PCN (Product Change Notice)

PCN Number: PCN_IndCHSA_20260316

Affected Series: WE-CHSA

Because of a database mismatch, Würth Elektronik eiSos will correct marking information, self-resonant frequency and update packaging drawing.

All WE-CHSA

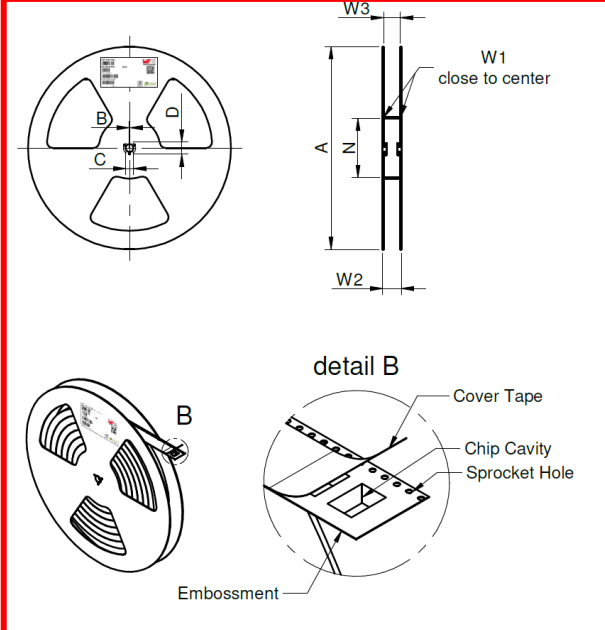
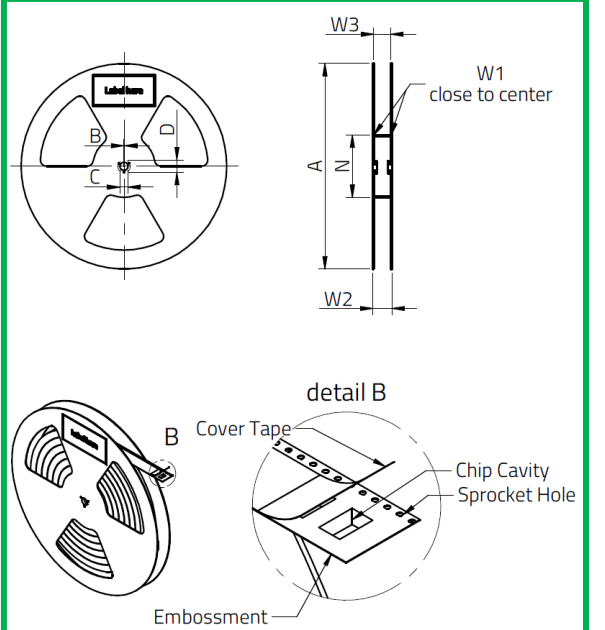
Before change	After change
